Pressure Switch and Check Valve Installation for C-60 & 80, WSC-60 & 80, PJR and PSR

Service Bulletin

Products affected: Pumps that use PC-741 check valve (PSR, PJR, PJR-A, C-60, C-80, WSC-60, and WSC-80)

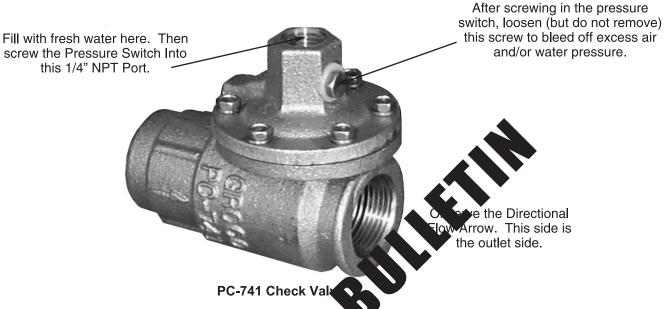
PC-741 Check Valve: Our goal to manufacture the finest products available has led us through a series of designances for pressure switches and check valves.

PC-741 Check Valve is standard equipment for \$10, 80, WSC-60, WSC-80 manufactured after 2/00, PJR and PSR pumps manufactured after 3/00 to is a recommended upgrade for all previous manufactured pressure pumps. PC-741 is designed an address the most common problem encountered with pressure switches in the marine environment - the aggress of nature of the liquid being pumped. In salt later, switches are subject to corrosion and salt built approximation or switch failure.

PC-741 is threaded on both ends for 3/4" FNPT and accepts any pressure switch with a 1/4" MNPT threaded port. The design features the environmental isolation of the pressure switch from the water being pumped through the system, so throat clogging, salt or sediment build-up, and corrosion are averted.

PC-741 Installation: Remove the old PC-740, PC-750, or P-9021 check valve. Screw PC-741 into place with 1/4" FNPT port facing up. Remove the plastic plug and fill the reservoir completely with tap water. Apply TFE thread tape to the pressure switch threads and screw in tightly.

nce the switch is tight and will not be moved again, the dexcess water pressure from the reservoir (you pressurized the reservoir when you screwed in the switch). Proper operation of the pressure switch depends on the complete absence of air in the reservoir. If abnormal pump operation is experienced upon start-up, check the water level in the reservoir and repeat the bleeding process.
